**Re: Reevaluation Report
 Horse Valley Road Horizontal Directional Drill Locations (S2-0157)
 Permit No. E50-258
 Toboyne Township, Perry County**

**HORIZONTAL DIRECTIONAL DRILL ANALYSIS
HORSE VALLEY ROAD CROSSING
PADEP SECTION 105 PERMIT NO. E50-258
PA-PE-0002.0000-RD & PA-PE-0002.0000-RD-16
(SPLP HDD No. S2-0157)**

Sunoco Pipeline, L.P.
Horse Valley Road HDD Location
Figure 2 - Geologic Map
 Toboyne Township, Perry County, PA
 Project No. 096302011

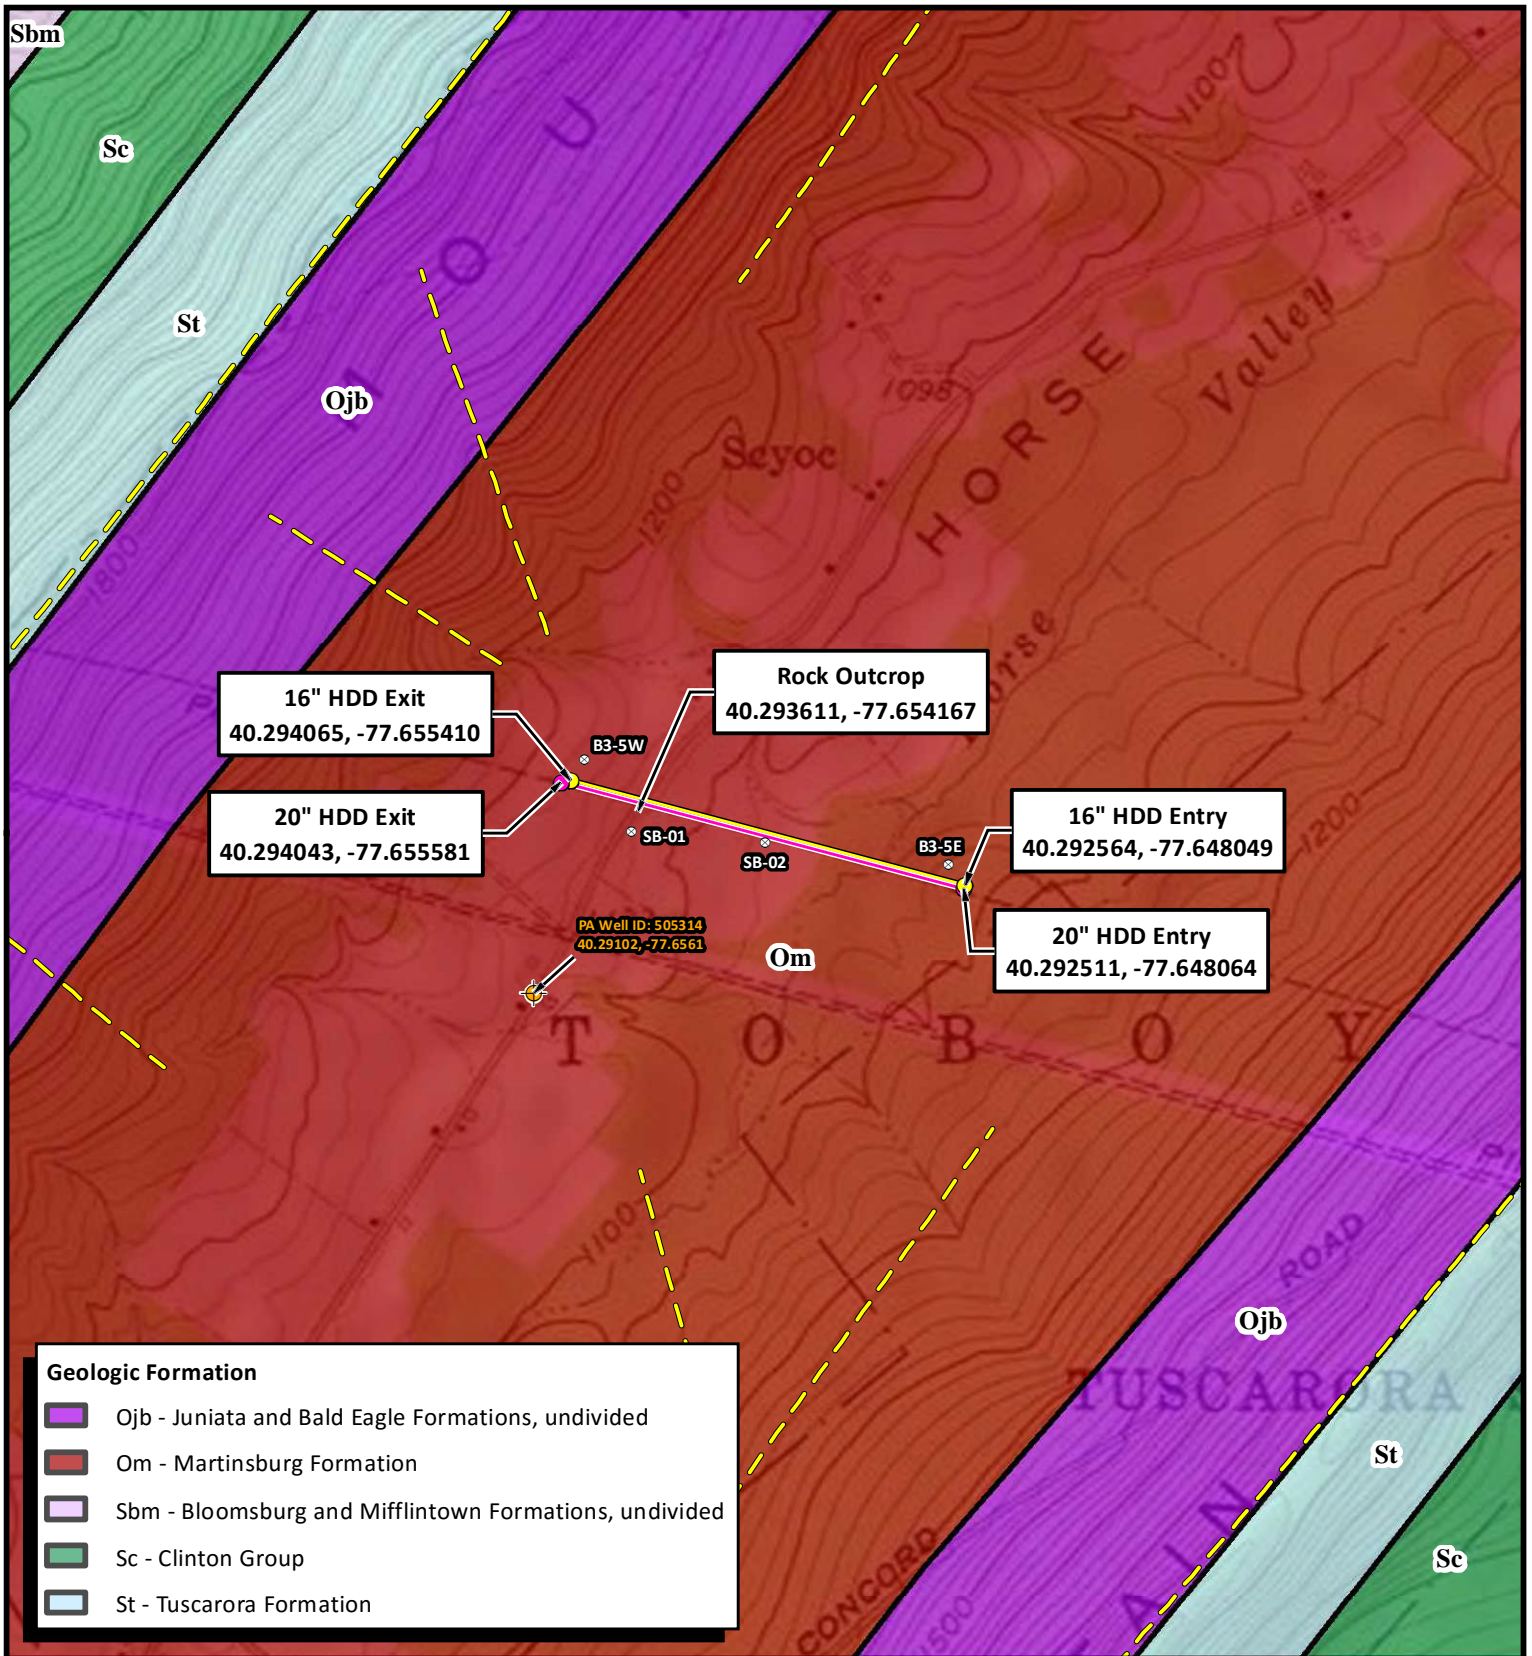
- 3. The entry/exit locations are inconsistently labeled throughout the report. Figure 2, Figure 3, and the E&S plans show the entry location on the western side of the site. All other drawings show the opposite. Please correct all inaccuracies in the drawing(s) to ensure they all are consistent with labeling of entry/exit locations.**

The correct plan and profile views for the revised 20-inch and 16-inch HDDs and applicable E&S plans are presented in the attached revised Reevaluation report.

Well Location Map
HDD# PA-PE-0002.0000-RD
Perry County, PA.

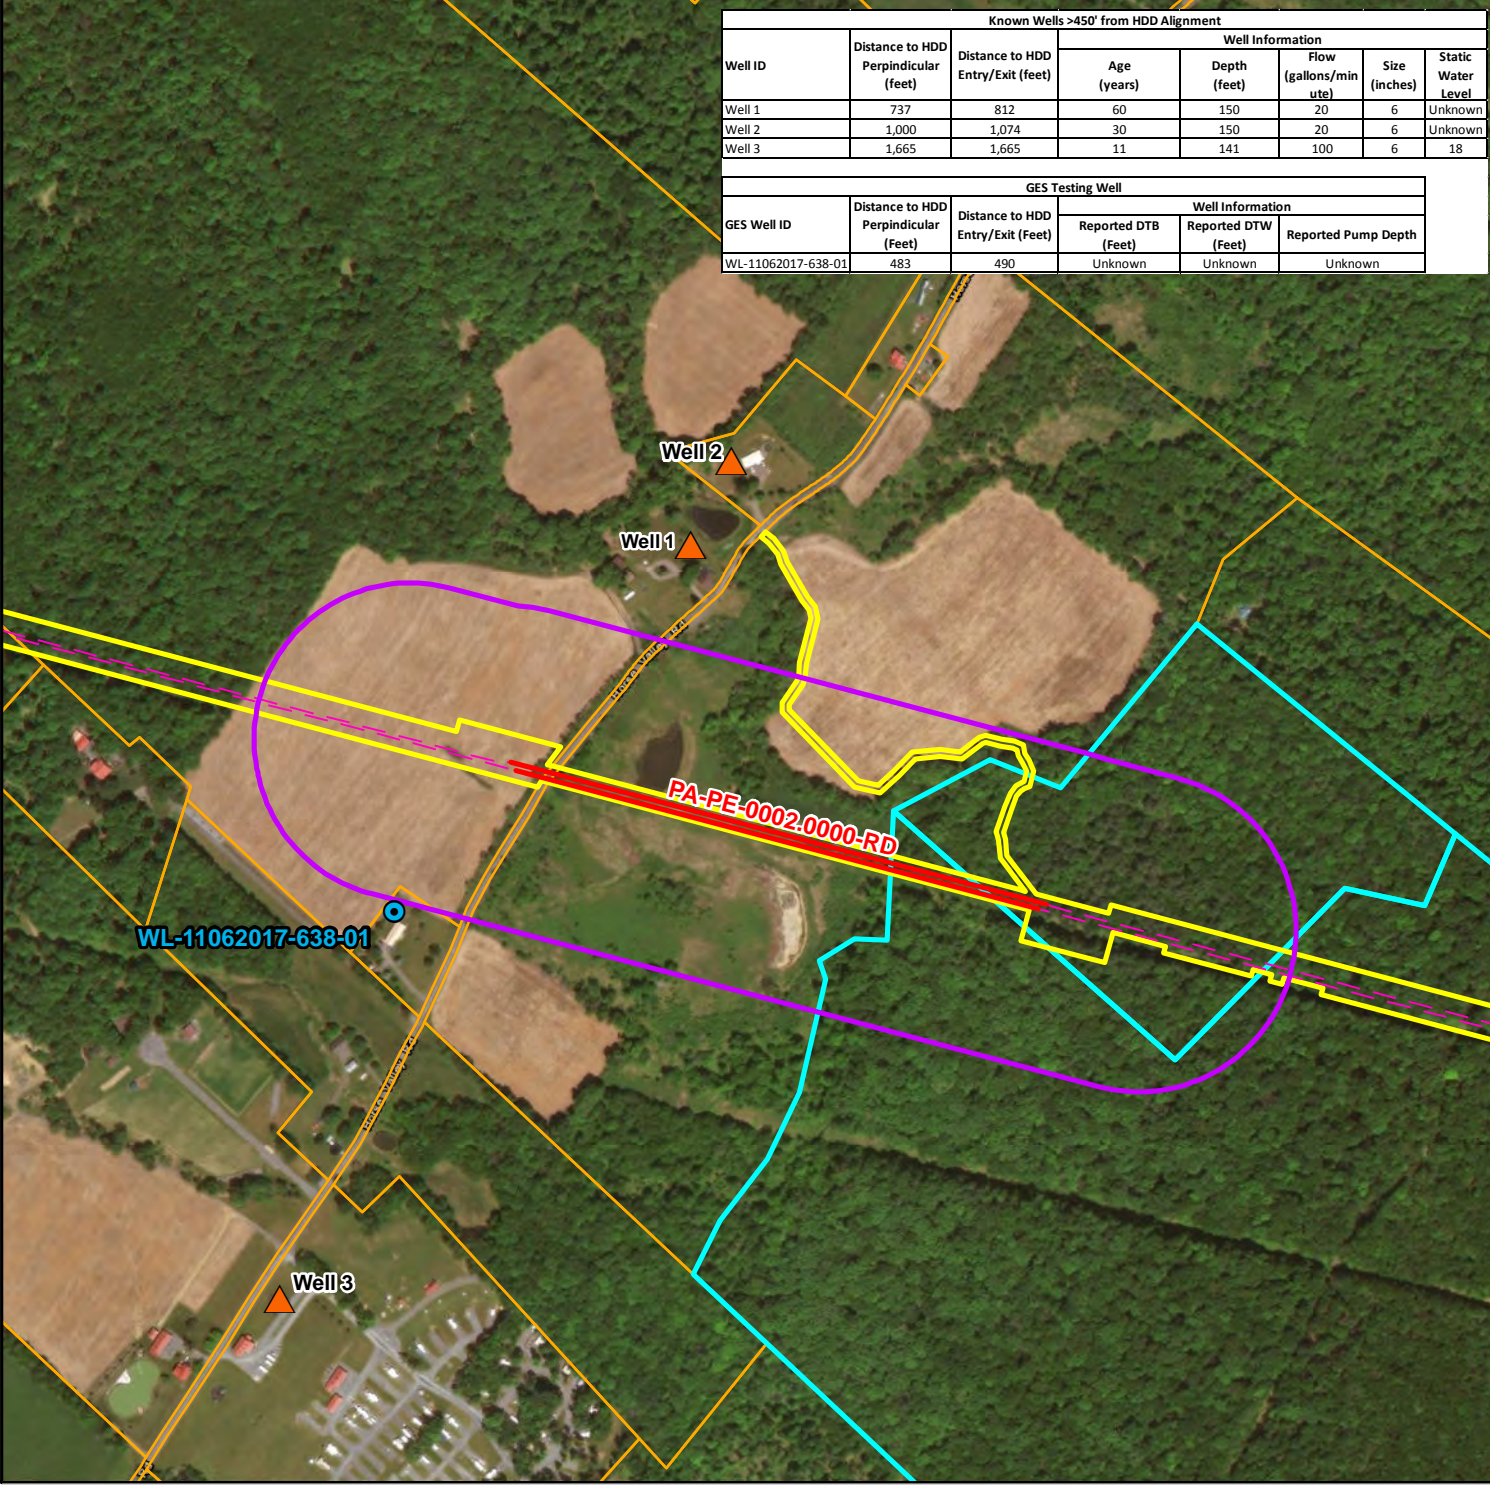
- 1. The well analysis of the Wildwood Family Campground water supply well states that “the movement of groundwater is a subdued reflection of the overlying topography”. Provide the information or data used to come to this conclusion. If information or data cannot be obtained, provide a re-analysis of the impact to the Wildwood Family Campground water supply well.**

The information on and analysis for the water well at the Wildwood Family Campground has been revised within the attached version of this Reevaluation report.

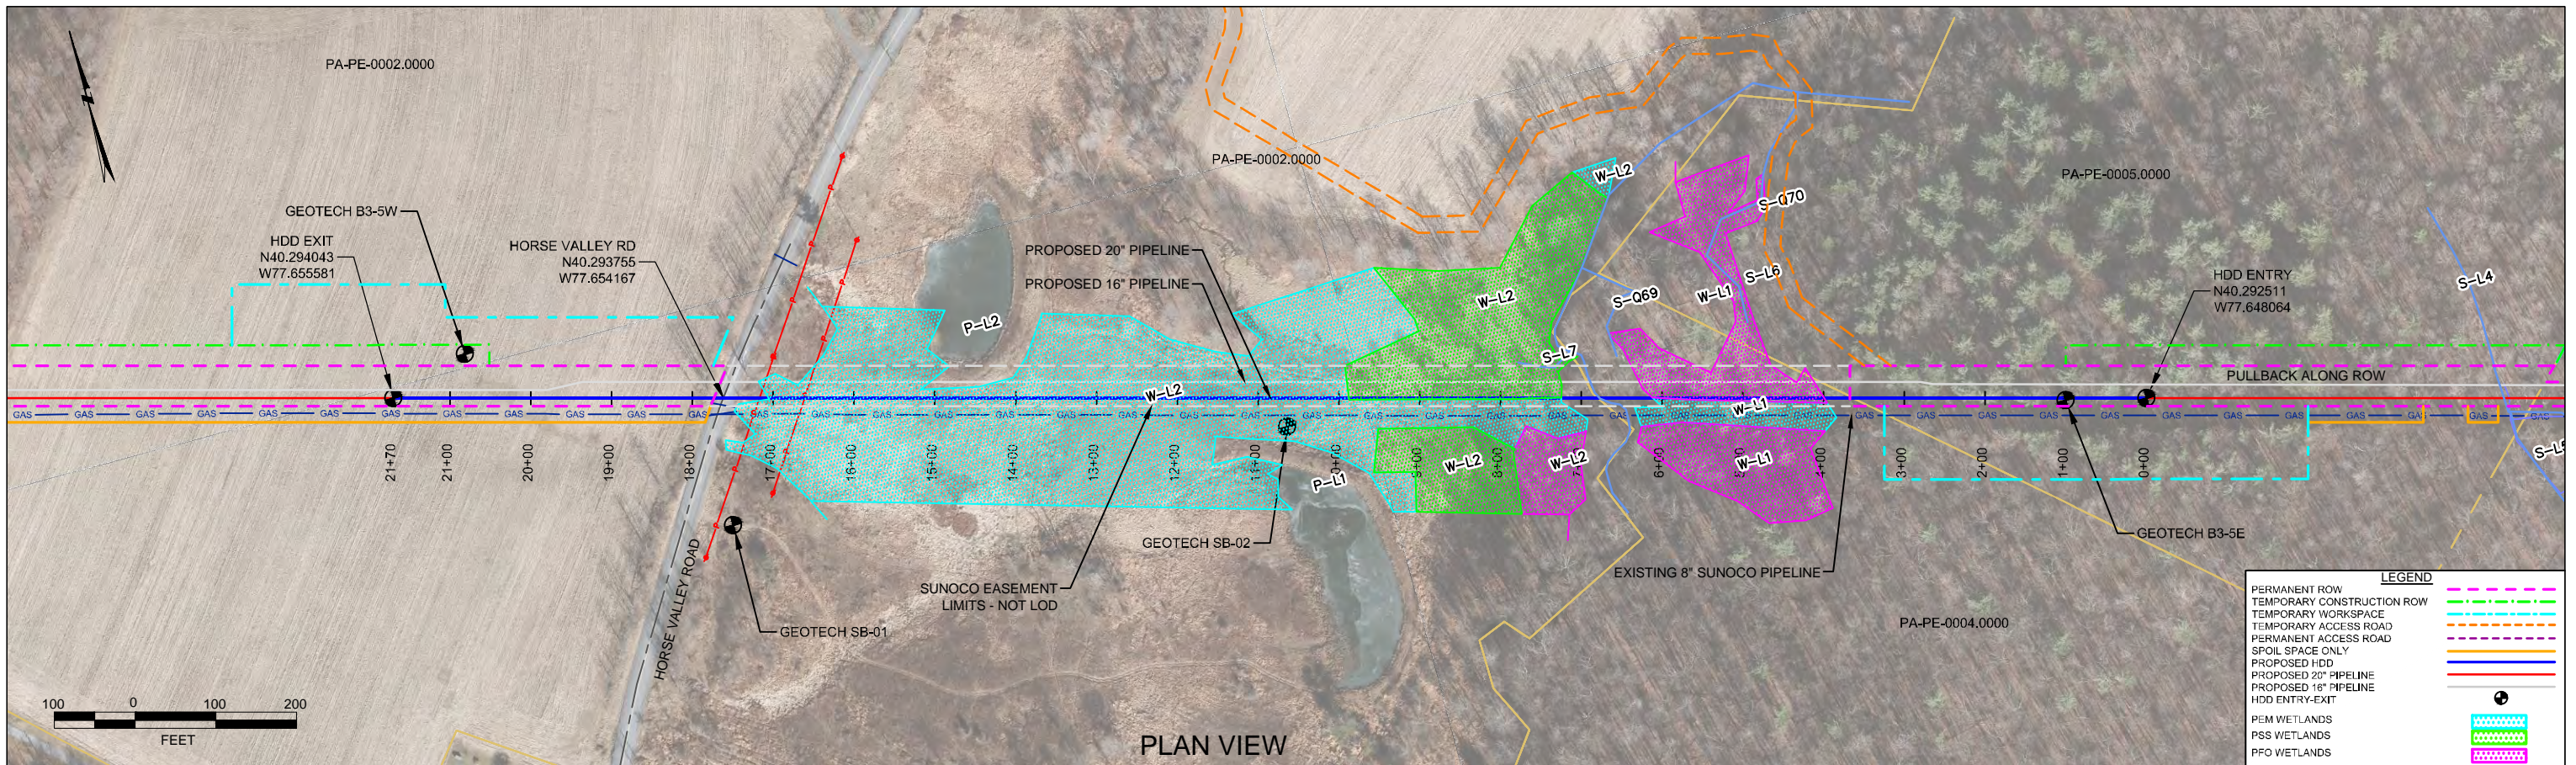
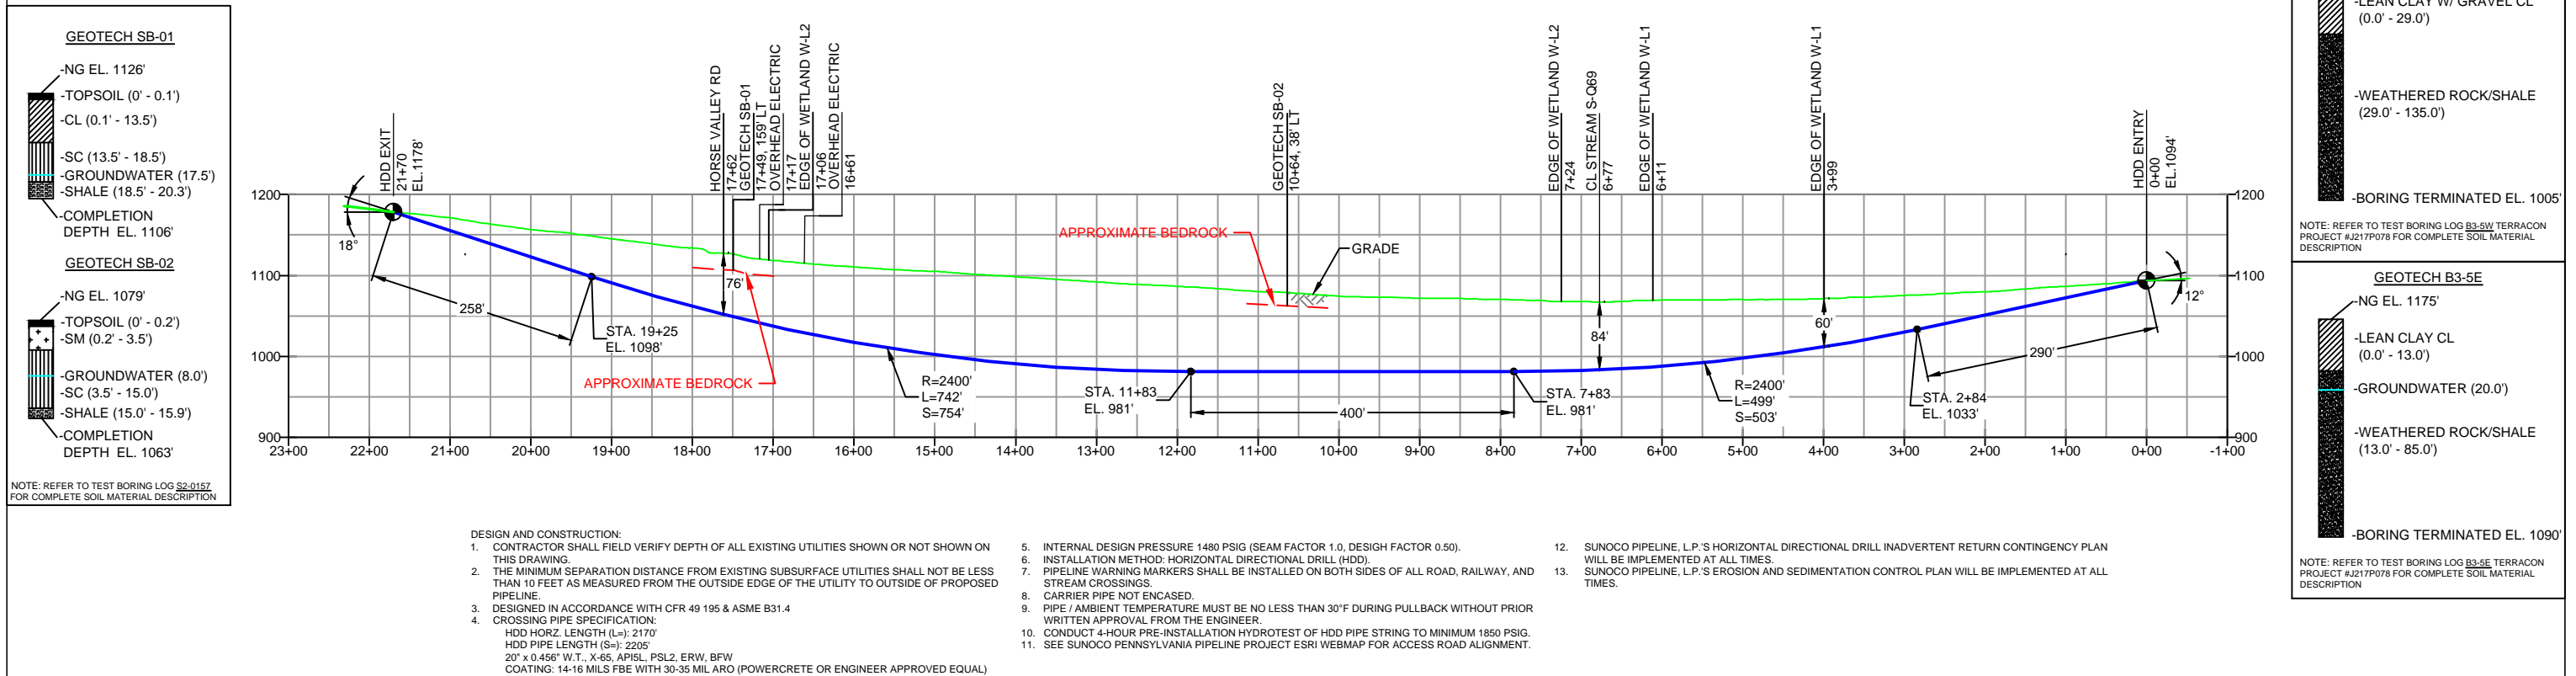
- 2. Attachment 4, Figure 2 is a copy of Attached 4 Figure 4 except it is labeled “Revised 20-Inch Plan and Profile”. Submit the correct revised drawing for the 20-inch HDD Plan and Profile.**

The correct plan and profile view for the revised 20-inch HDD is presented in the attached revised Reevaluation report.
